TOGA Central

Response to Submission

TOGA

November 2022

Basement 2 floor plan

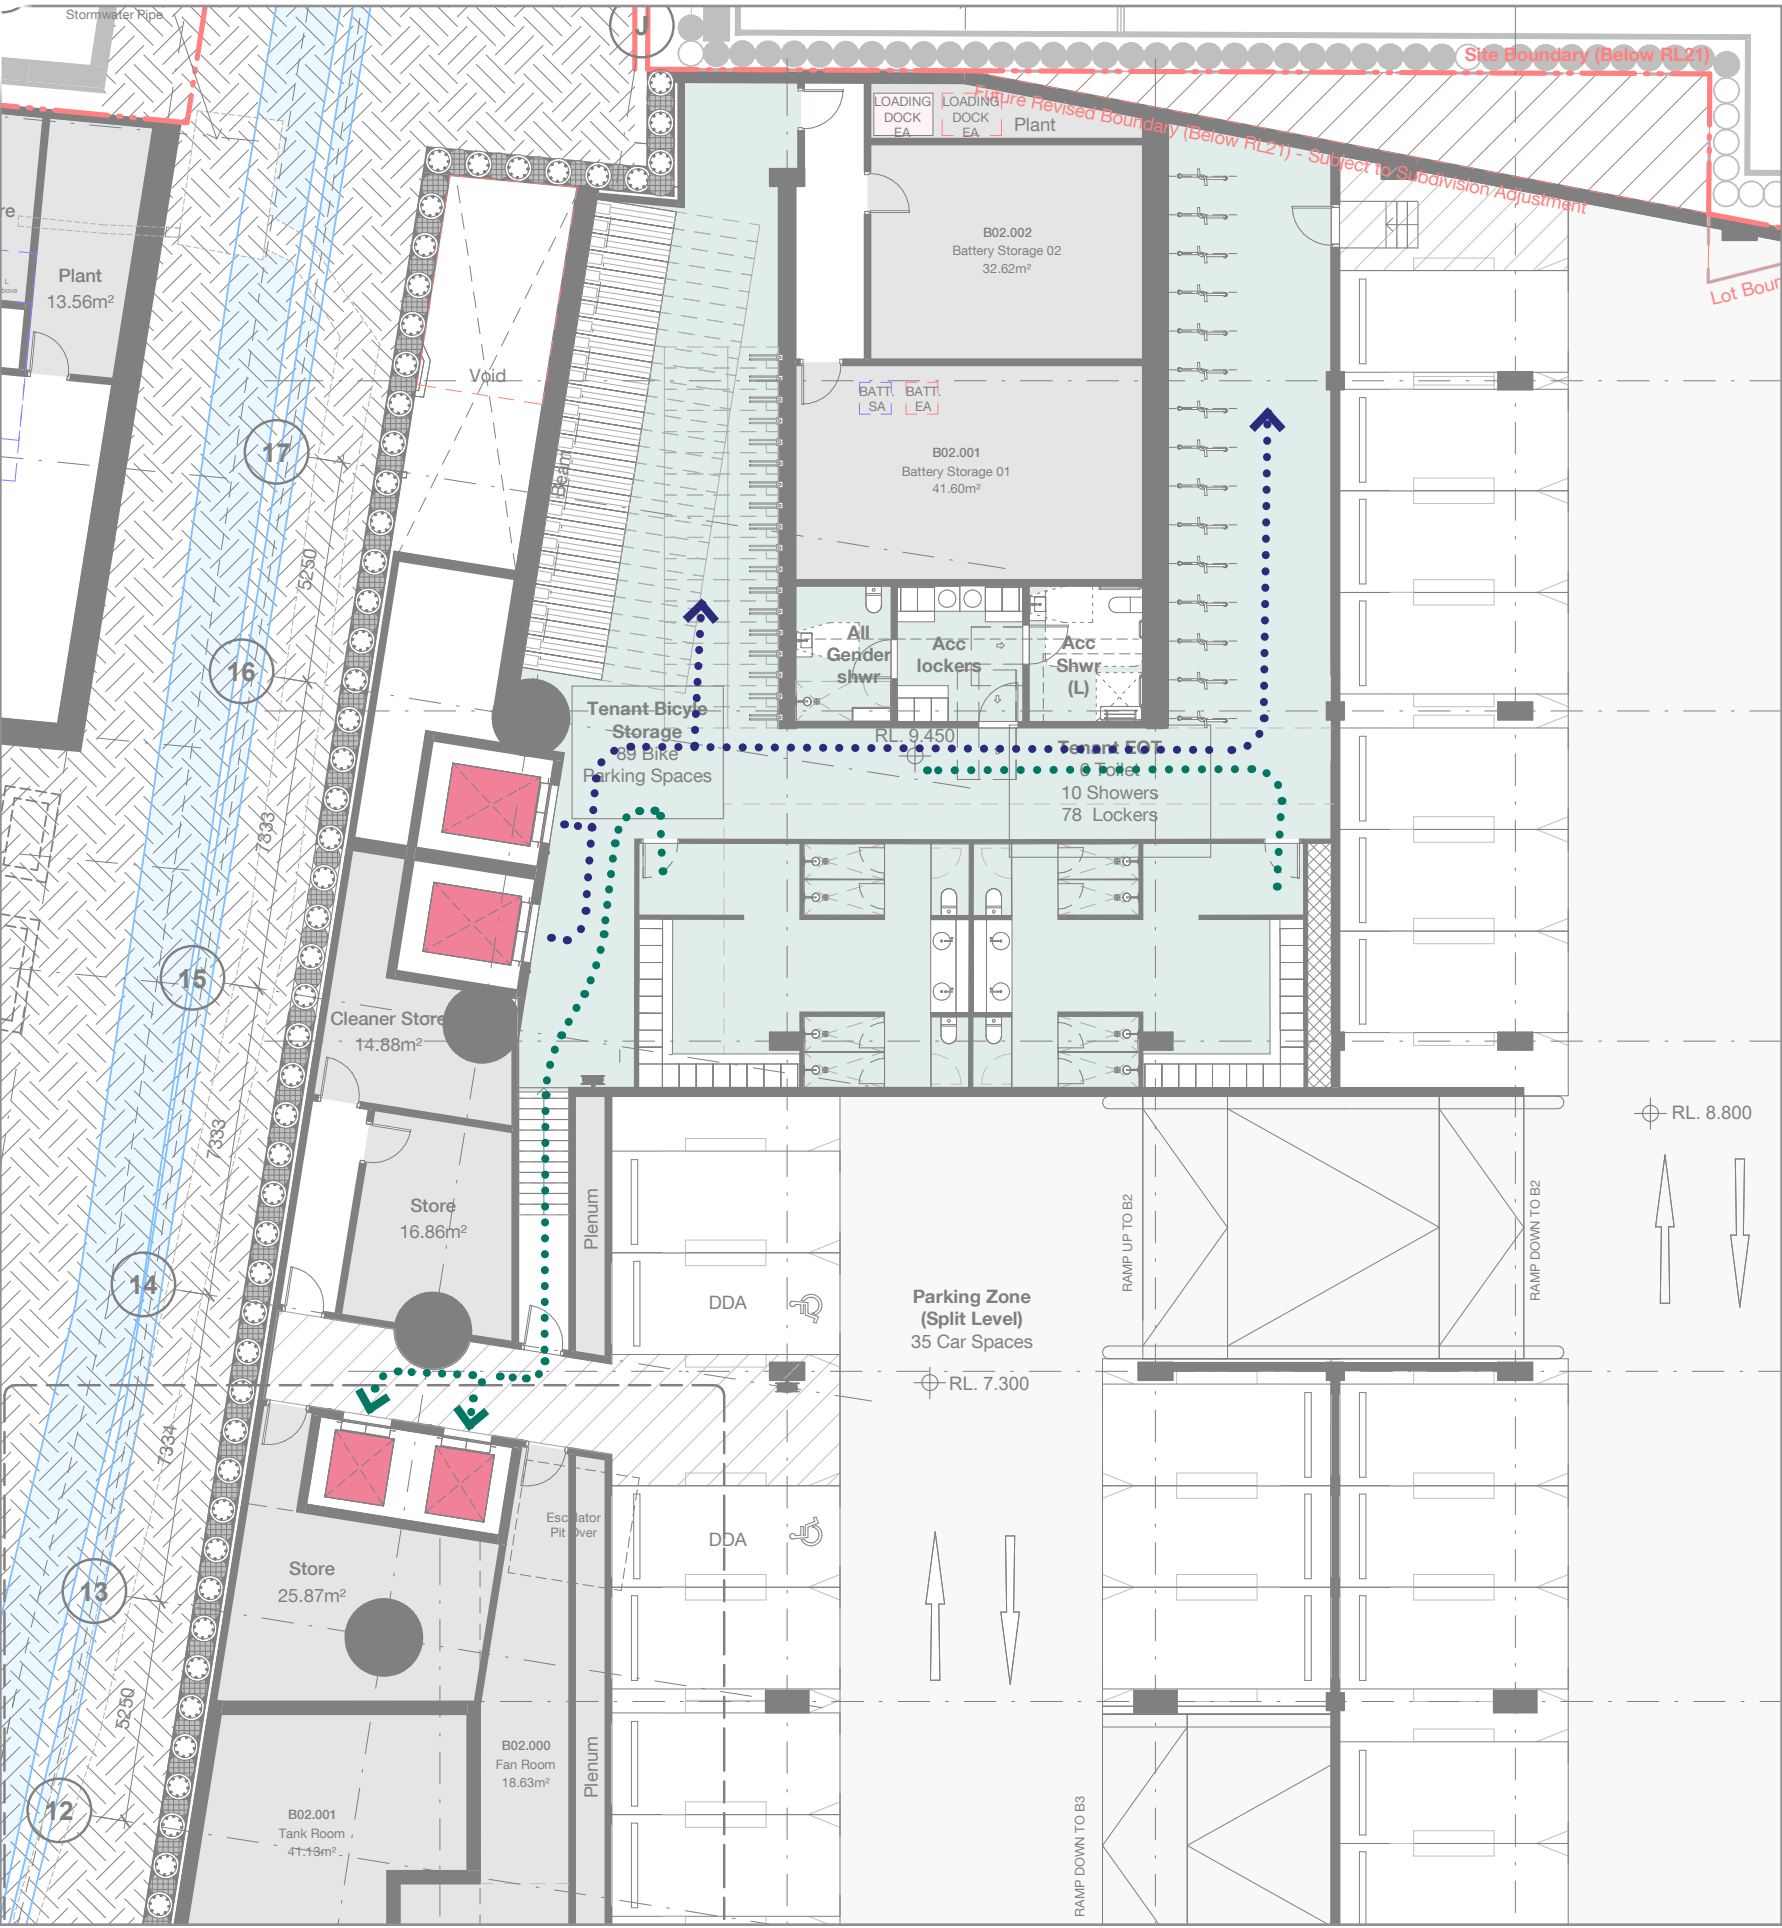
21 c) Increase bicycle parking provision.

A second End of Trip facility has been added to increase numbers to 223 bike spaces, 223 lockers and 28 showers (refer to Transport Report by Stantec).

Cyclists will enter from Lee Street via a short stair and access two goods lifts (shared with retail functions), which can hold two bikes each. These lifts open onto the new EOT facility on basement level 2.

People leaving the EOT facility will have access to the two car park lifts leading to the lobbies on Ground Floor (RL 20.8).

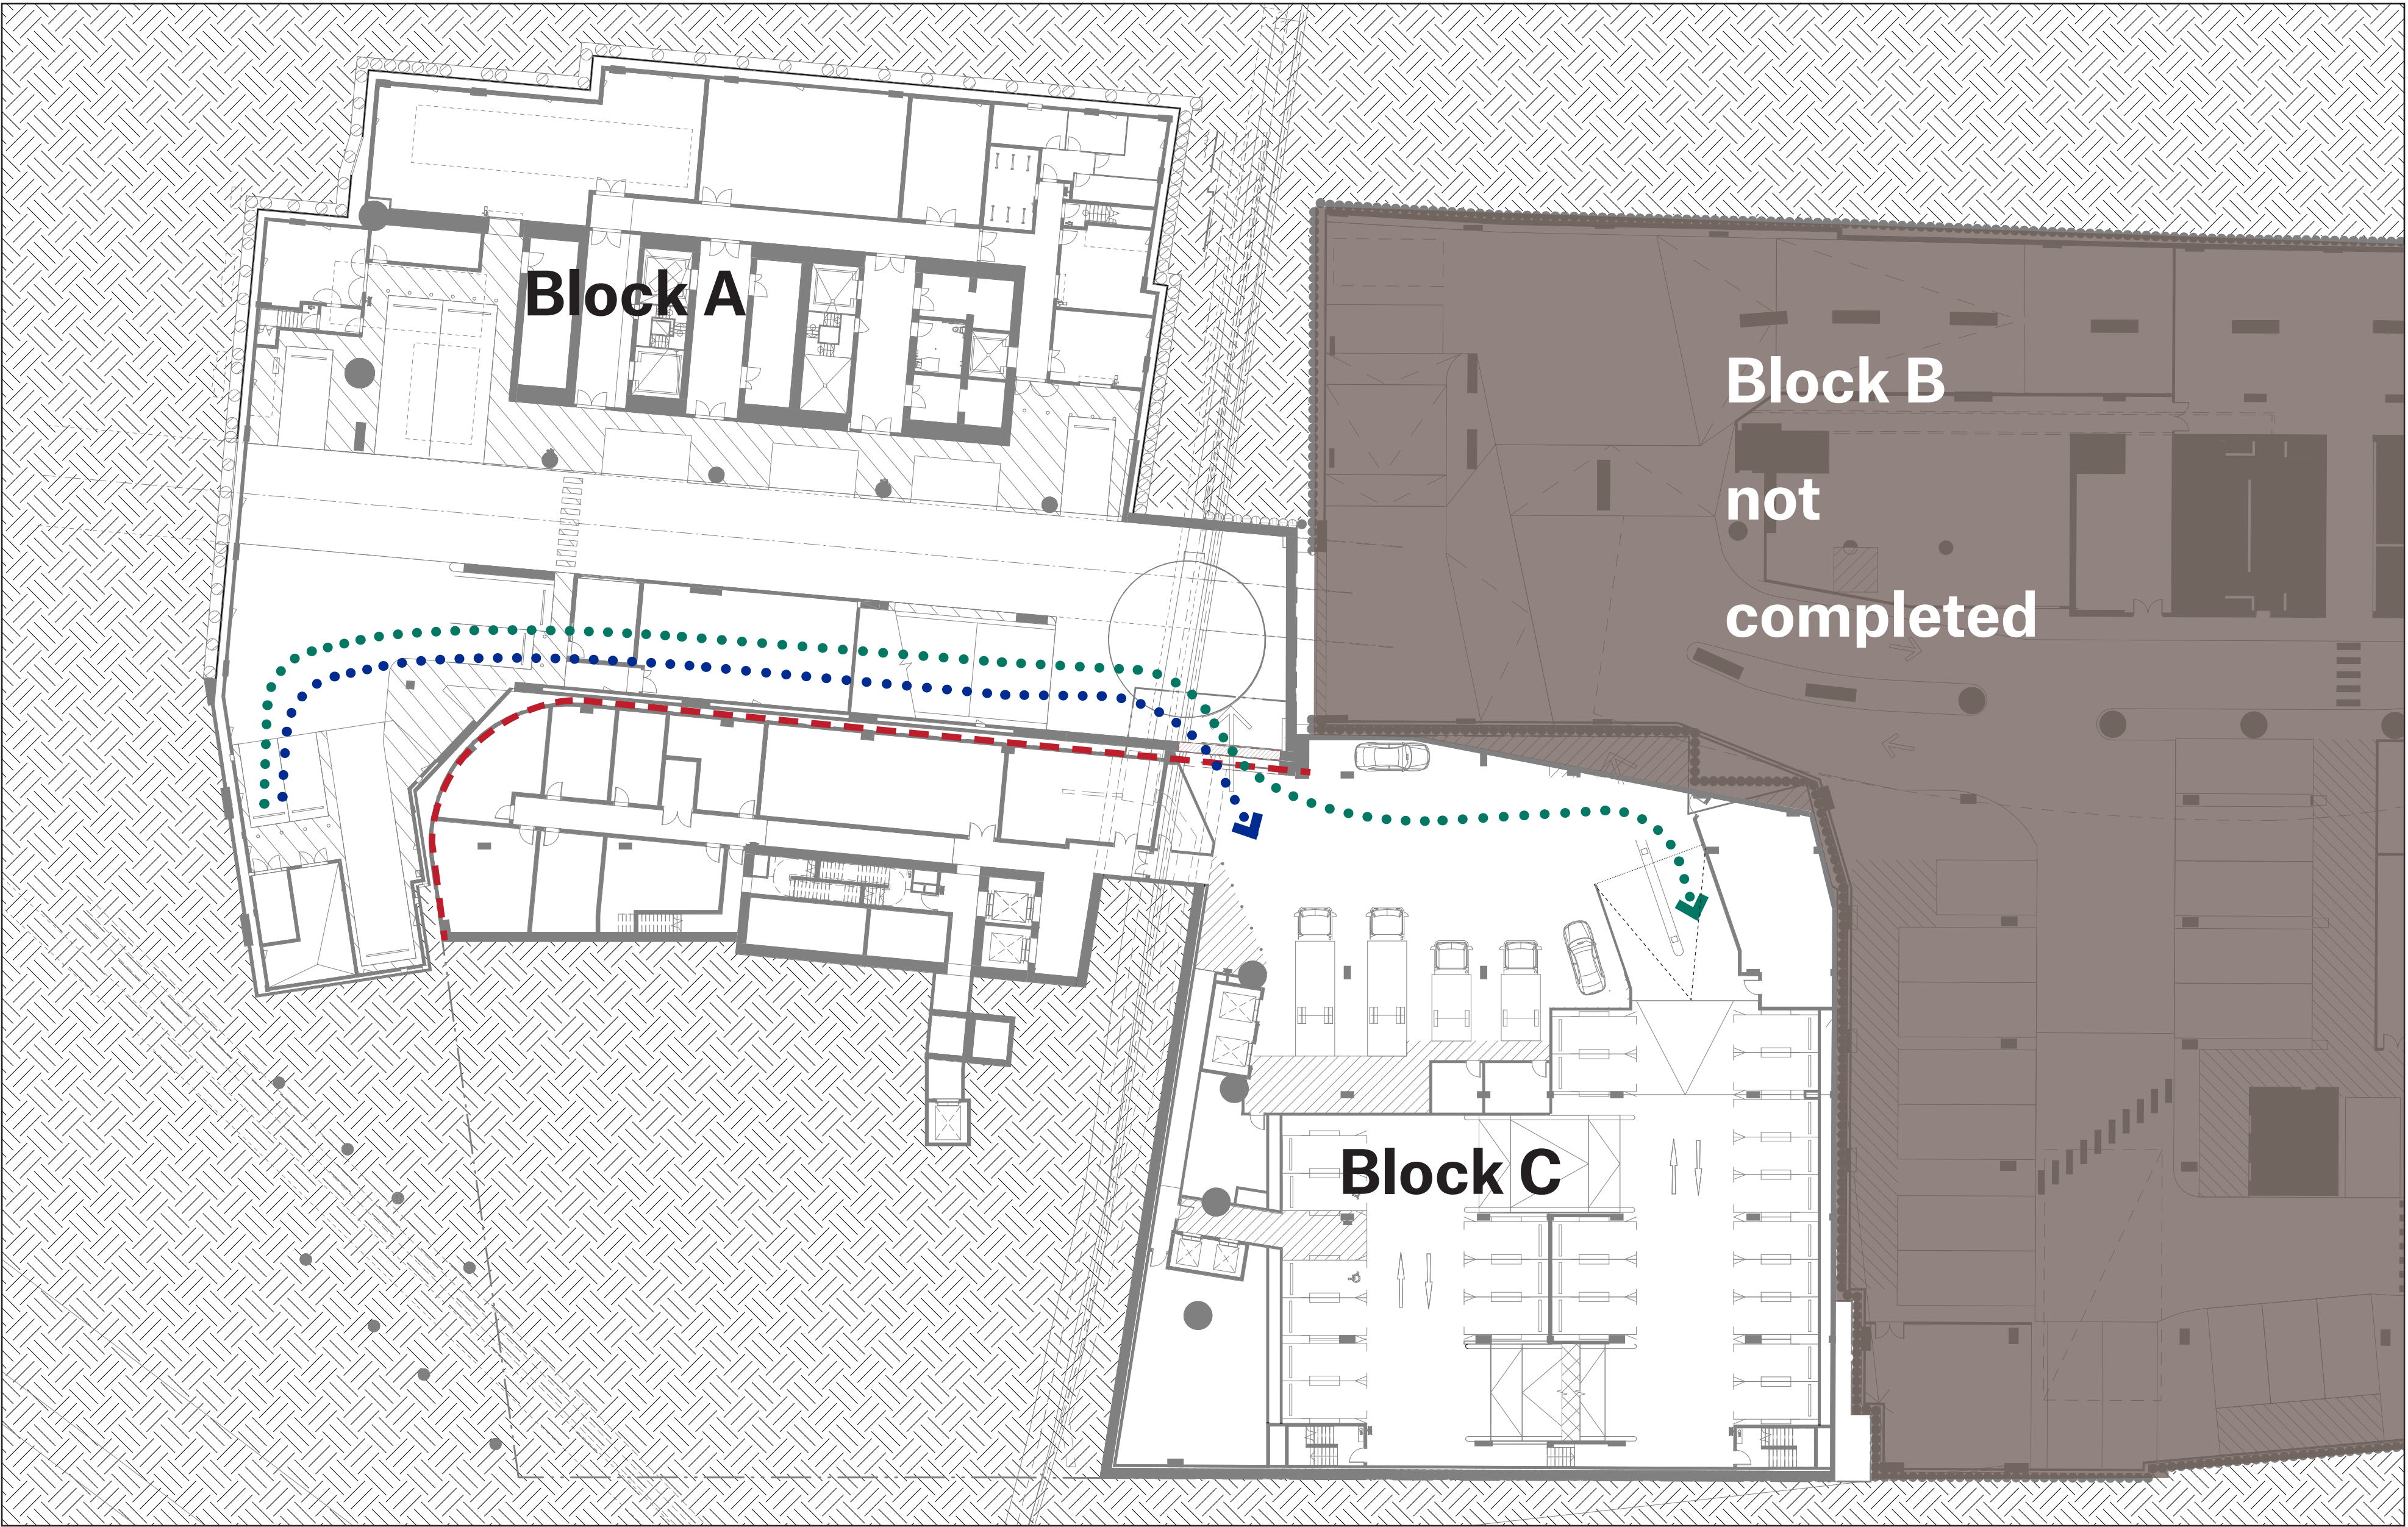
Provide a basement integration plan that clarifies the configuration of basement access for Day 1 and Day 2 scenarios.

Adjacent diagram describes a development scenario (Day 1) with Block A and Block C developed, but Block B not completed.

In this scenario, All vehicles will enter and exit the Atlassian dive ramp from Lee Street. A turntable on Block A land in front of Block C loading bay will enable vehicles to turn.

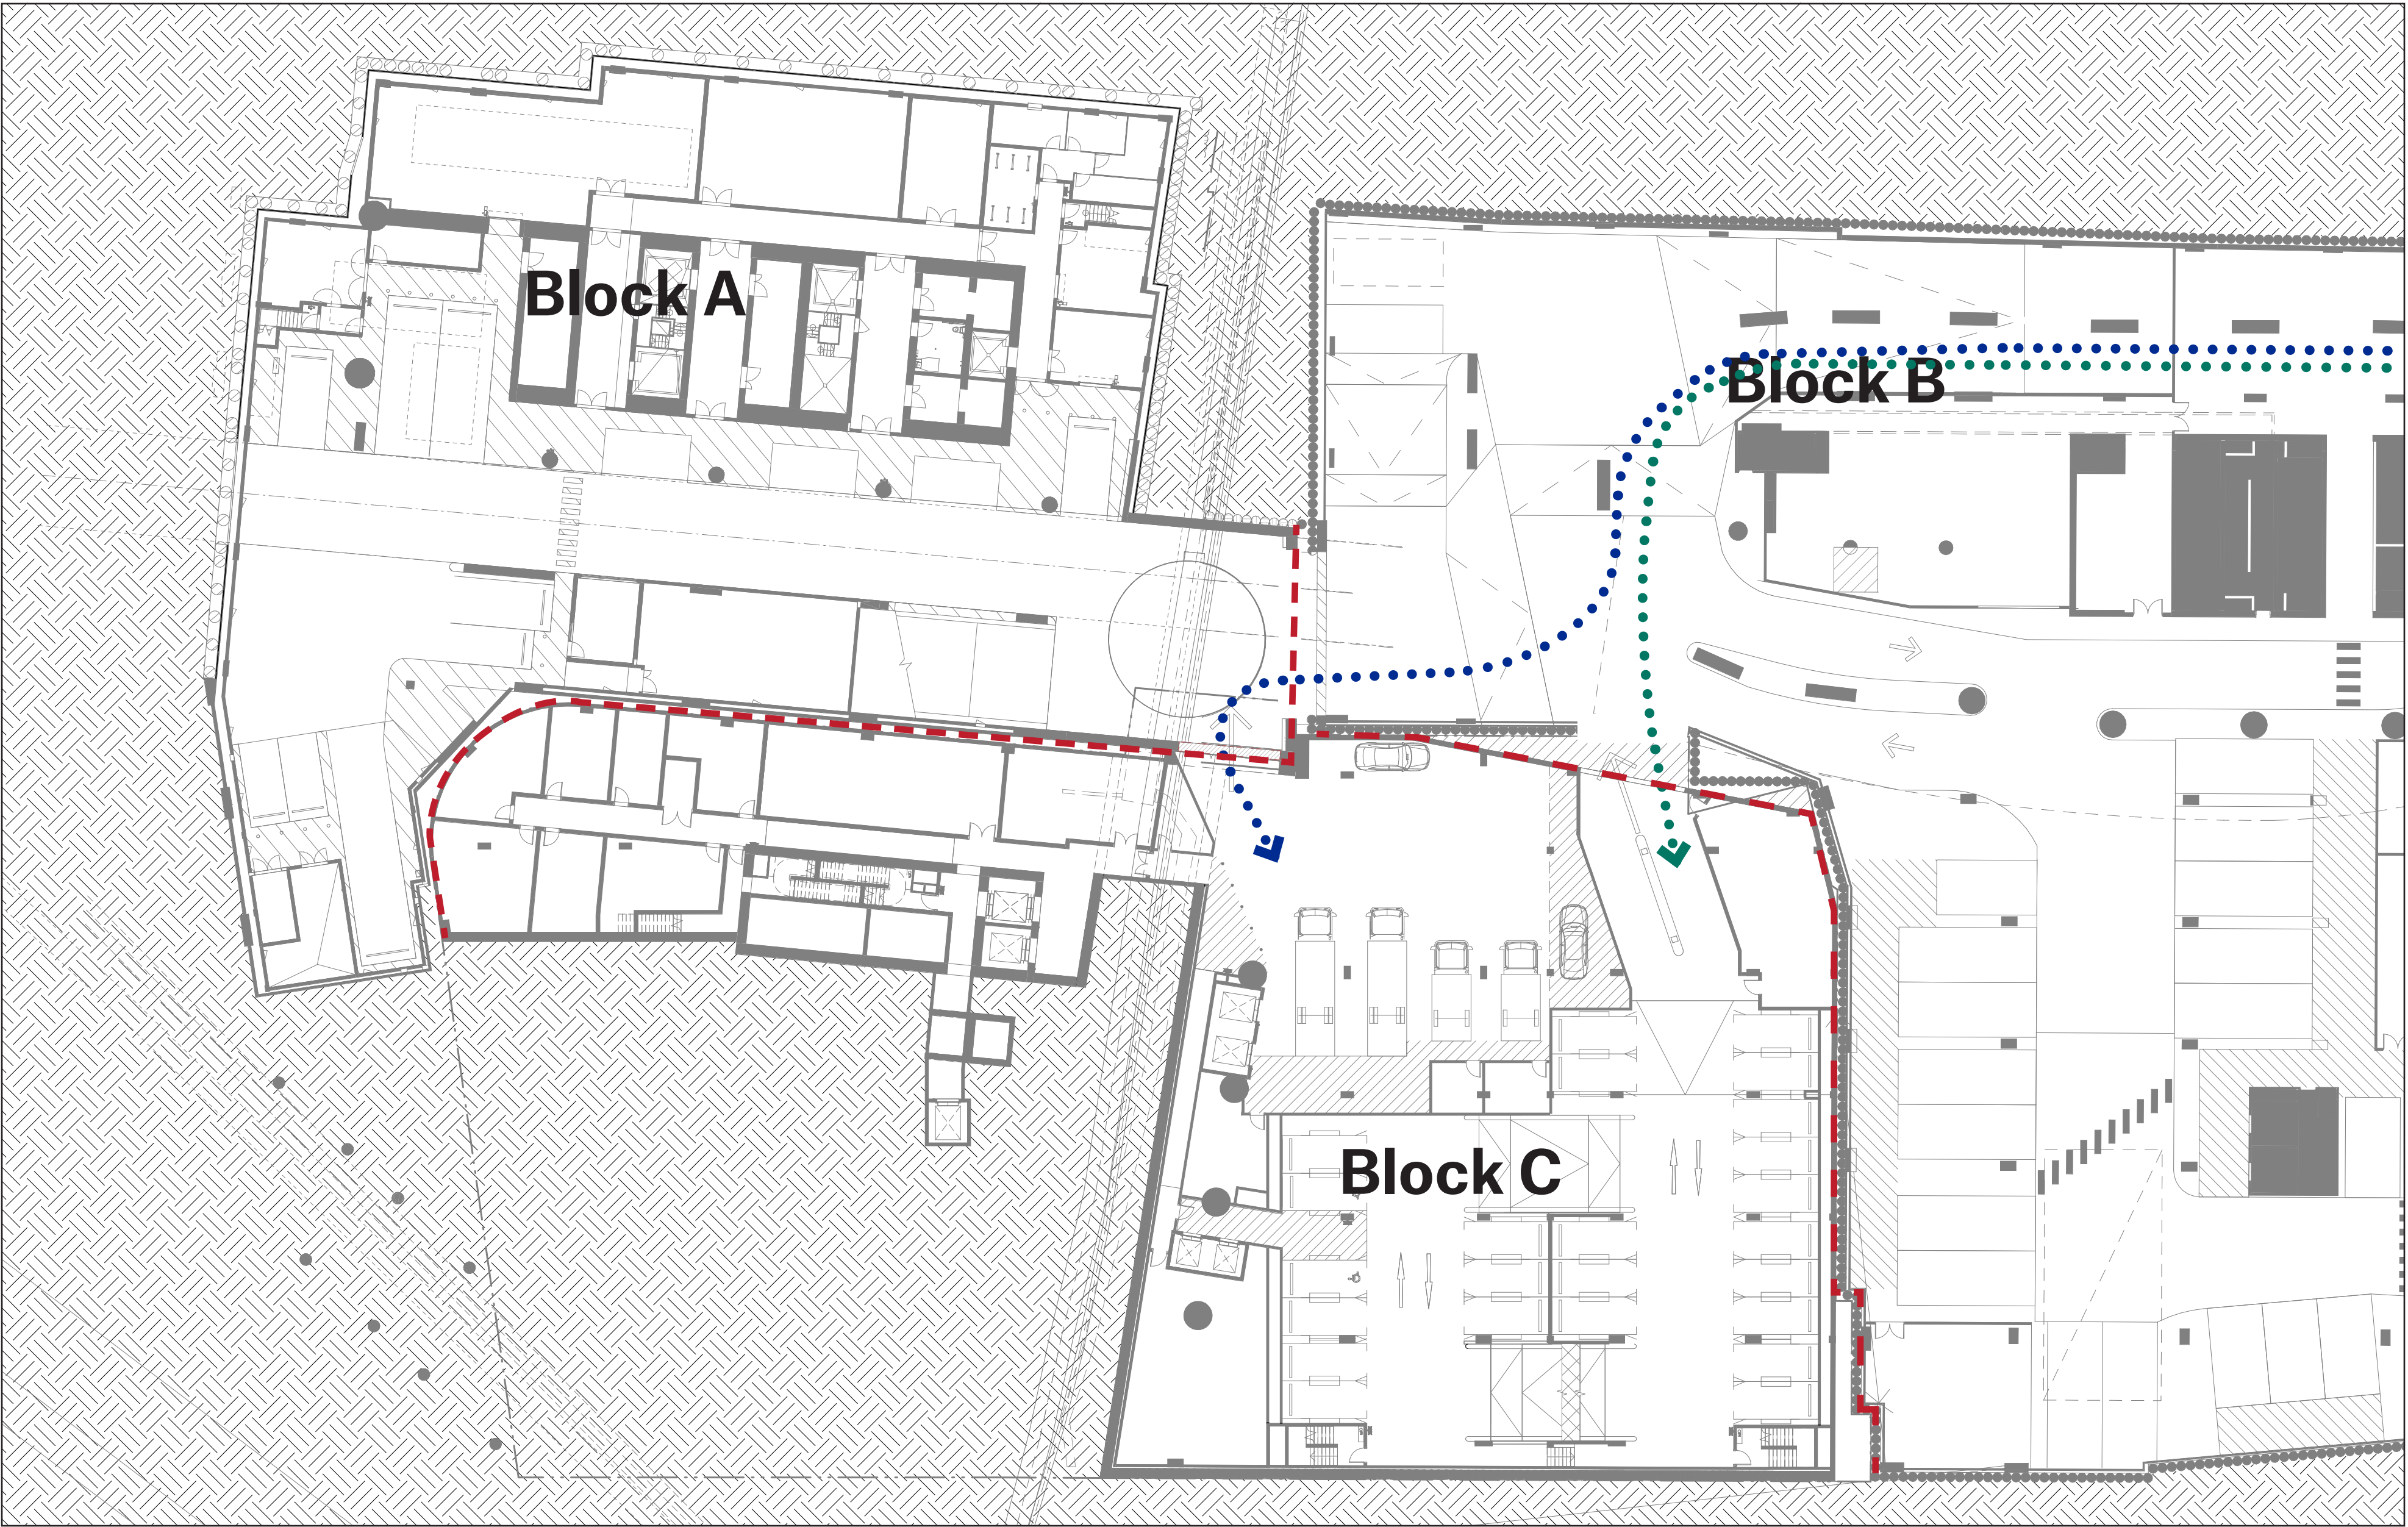
Provide a basement integration plan that clarifies the configuration of basement access for Day 1 and Day 2 scenarios.

Adjacent diagram describes a development scenario (Day 2) with all three Blocks completed.

In this scenario, all vehicles will enter via Block B. The Atlassian dive ramp will be closed and offered as public domain at Street level.
